SUBJECT: Ed Burns Arena Electrical Upgrades

ADDENDUM NO. 2

Project: Arlington Ed Burns Arena
Arlington, MA.

The following is in response to the electrical contractor's questions from the electrical contractor bidding on the aforementioned project.

SKE-1

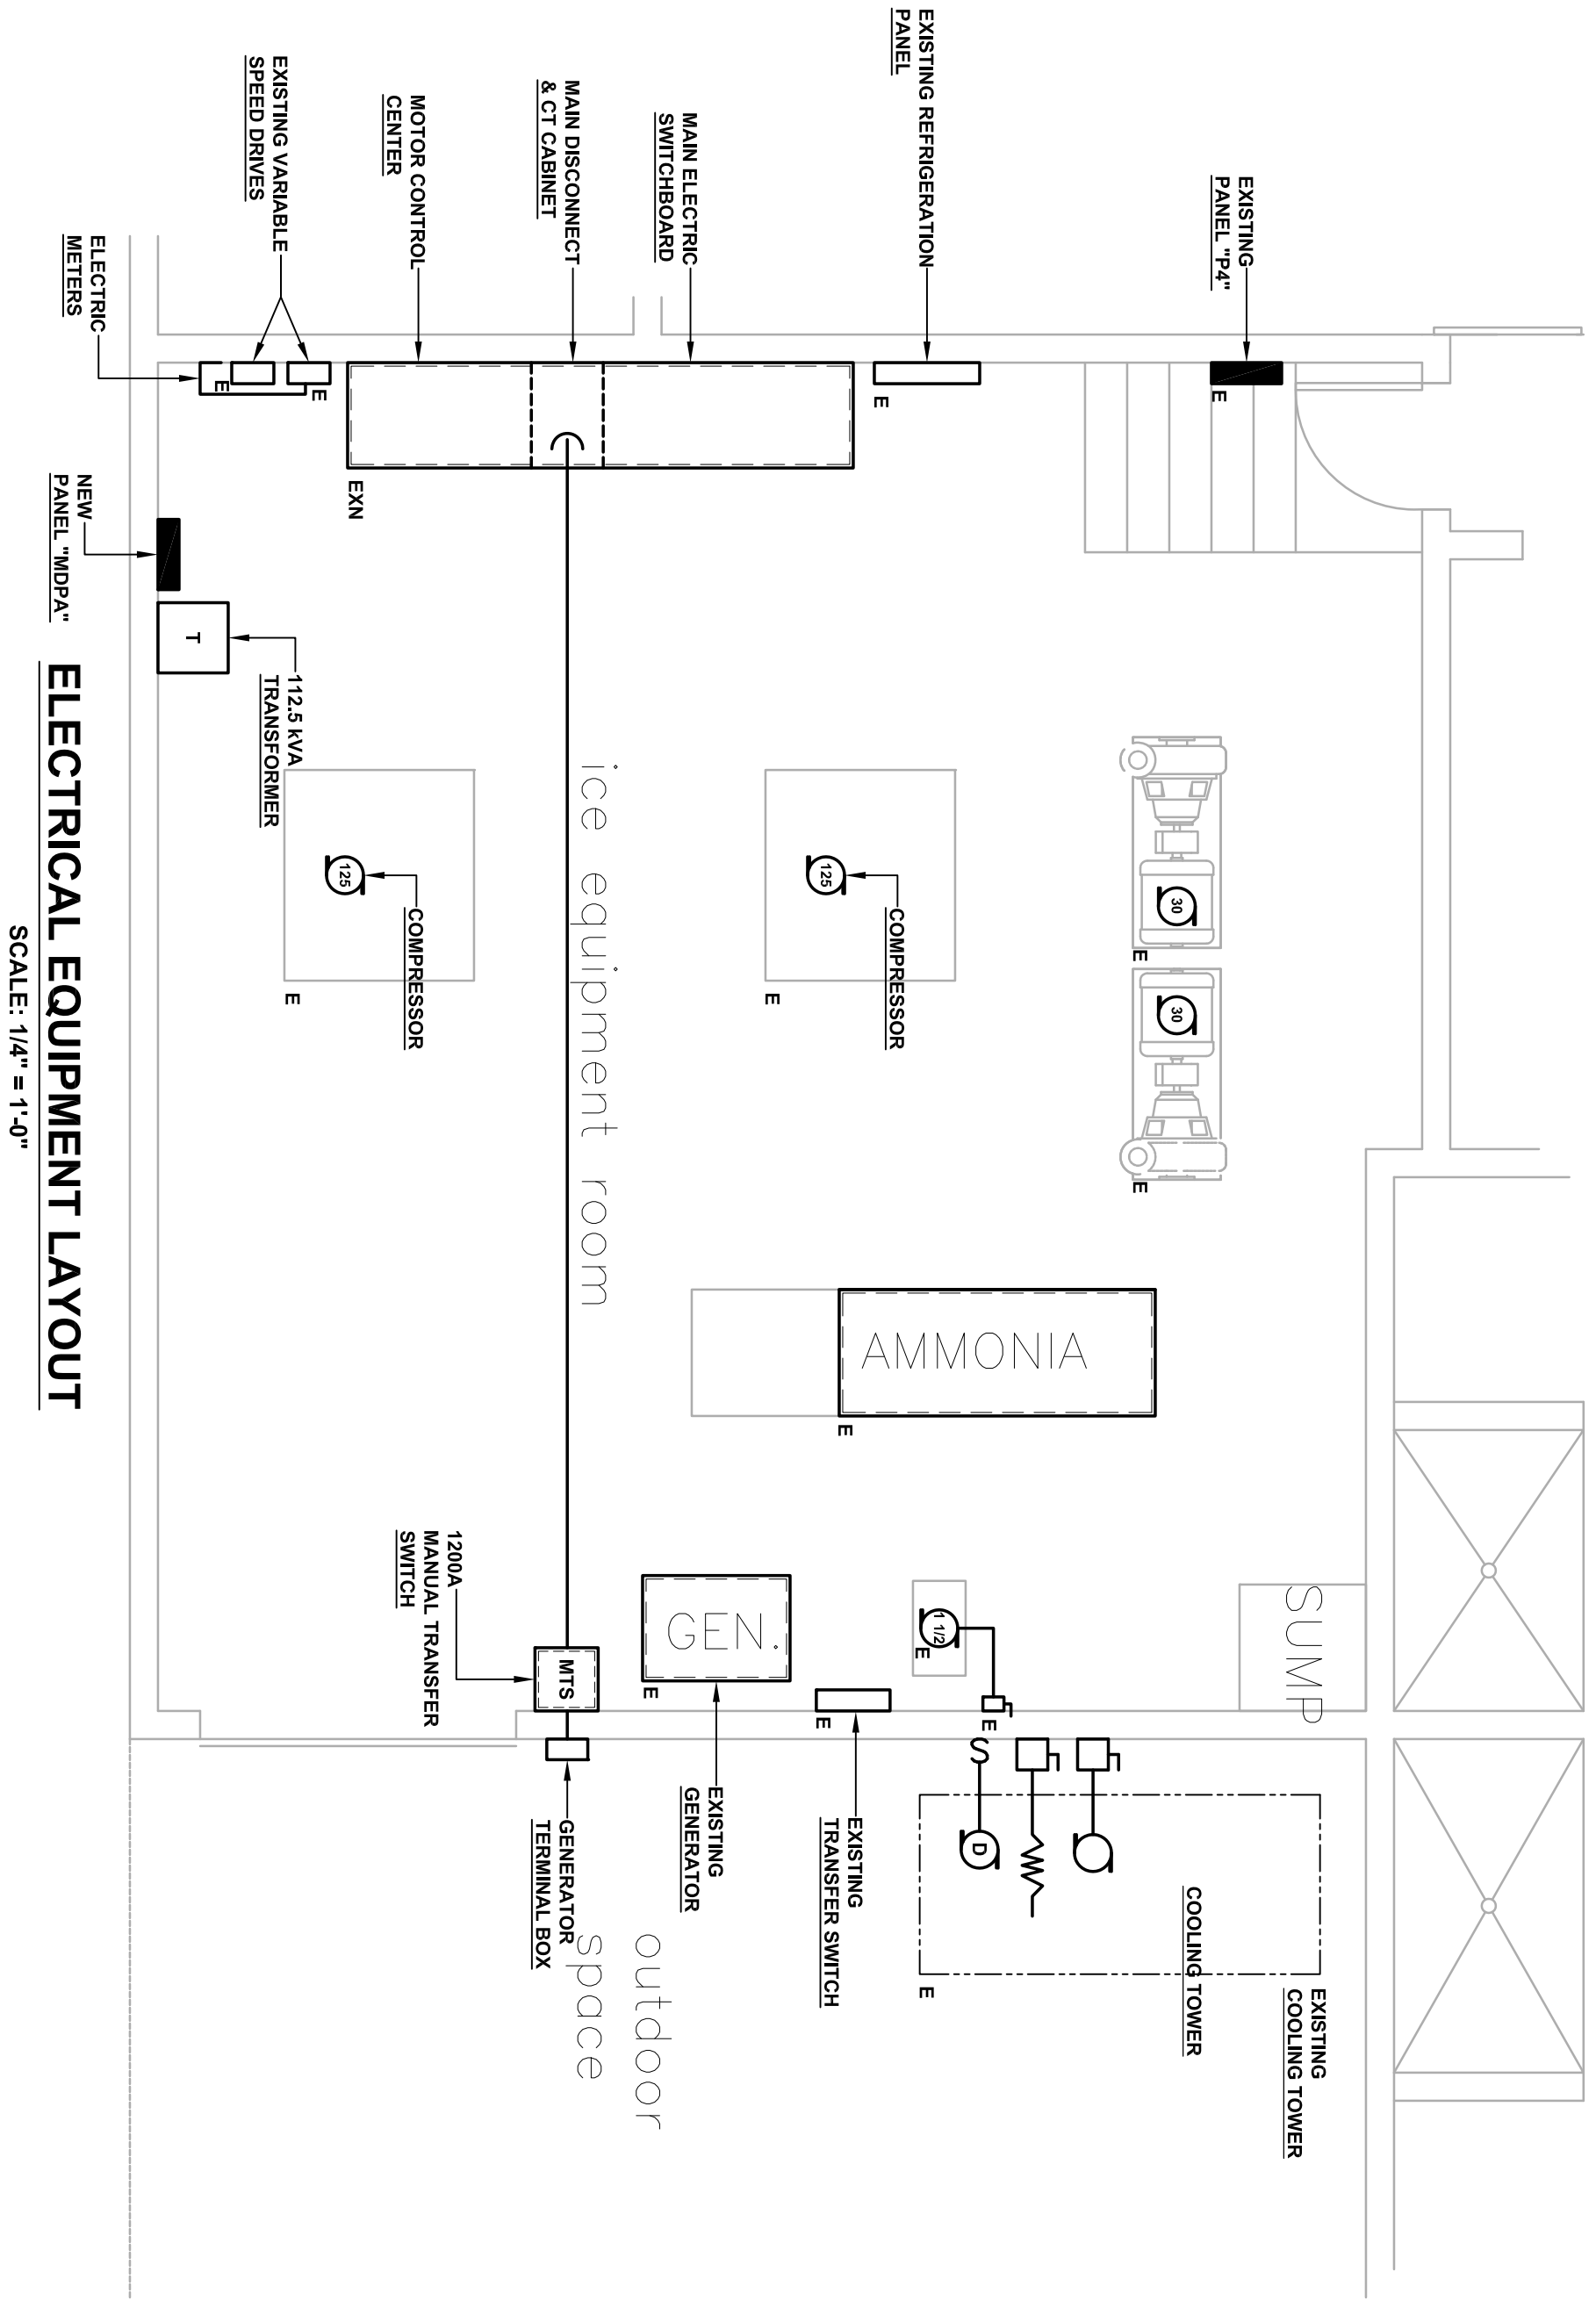
12. Is a manual transfer switch required for this project (it is in the spec)? If one is required for the generator terminal box, where is it to be located?

18. 112.5kva transformer and new panel "MDPA" shall be relocated as indicated on sketch SKE-1.

Response: A manual transfer switch shall be required. (See sketches SKE-1 & SKE-2).
